ADDENDUM NO.4

PROJECT: Cumru Fire Department

MWS PROJECT NO: 18-036

DATE: 1/24/2024

SCALE	AS NOTES
PROJECT NO.	Z057000415
DRAWING NO.	166.5
SHEET	OF

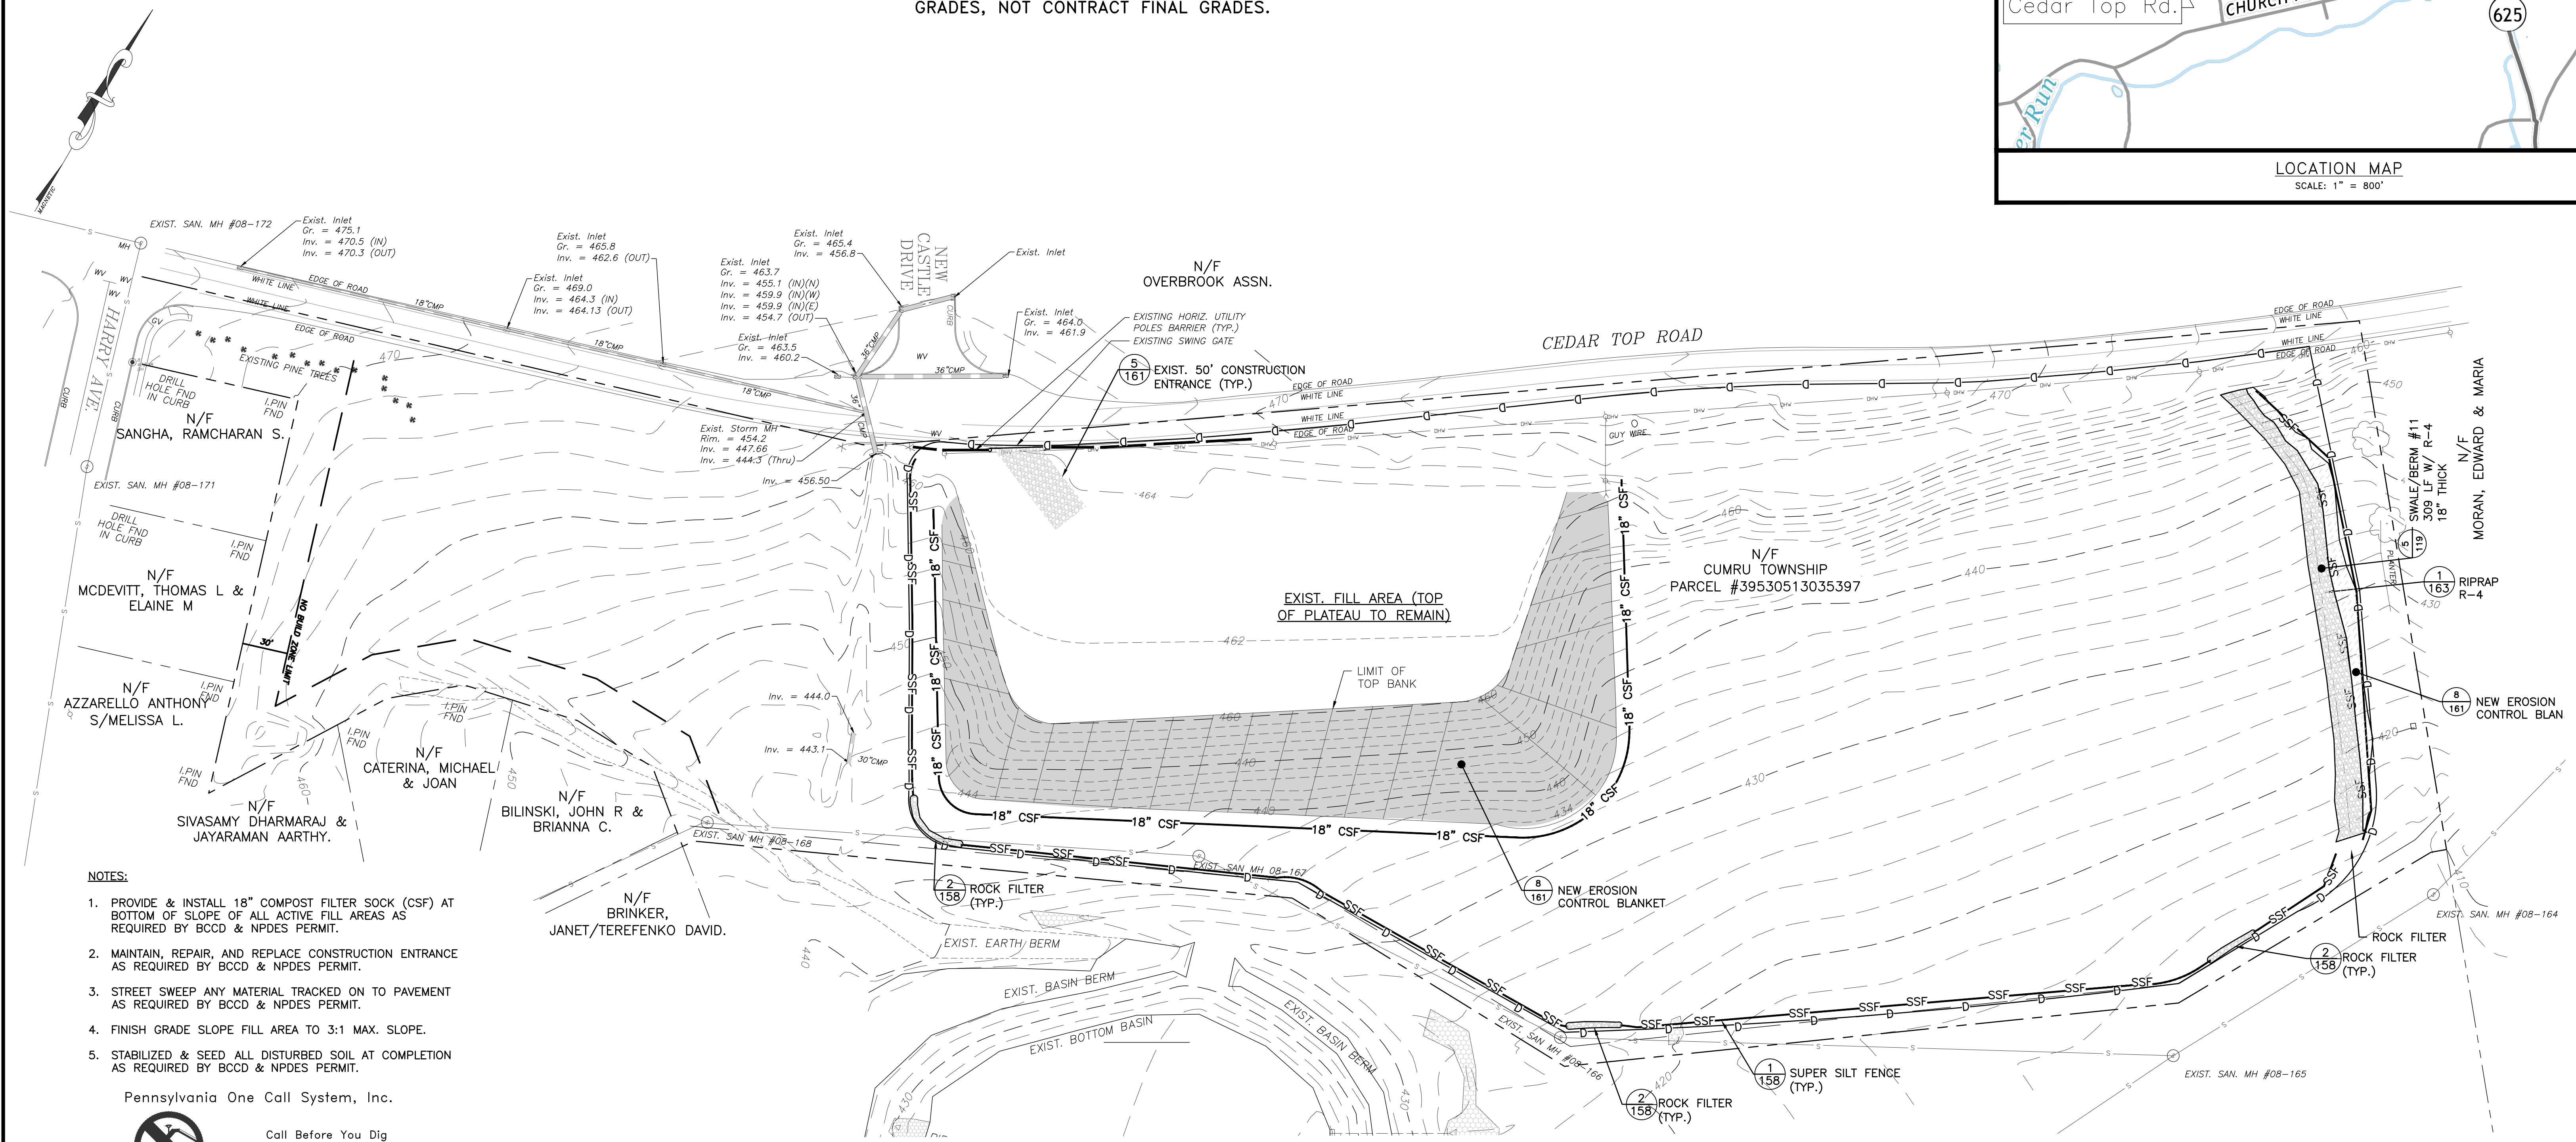
1. Add drawing 166.5 – CONSTRUCTION PLAN FILL GRADING AND STABILIZATION CUMRU TOWNSHIP SPOILS STOCKPILE LOCATION, dated 01/23/24 to the construction drawing set.

12.) **QUESTION:** Is the Township owned dump site on Cedar Top Rd available for use in disposing of excess fill material / spoils, unsuitable soils ? If so, are there any specific requirements that go along with using the area (push off, erosion control, seeding, etc.?) ?

20.) **QUESTION:** Or are these materials permitted to be left at the stock pile area on the opposite side of Welsh Road?

RESPONSE: Yes, the Township owned site is ended to be used. NO MILLINGS. The contractor(s) would be required to be a co-permittee on the NPDES permit.

RESPONSE: Materials may be stockpiled in the designated area on the opposite side of Welsh Road for top soil only or at Ashley Run for clean spoils/non-topsoil. A site plan for Ashley Run has been included in this Addendum. Both sites will require the contractor to provide erosion and sediment control measures per the appropriate plans.
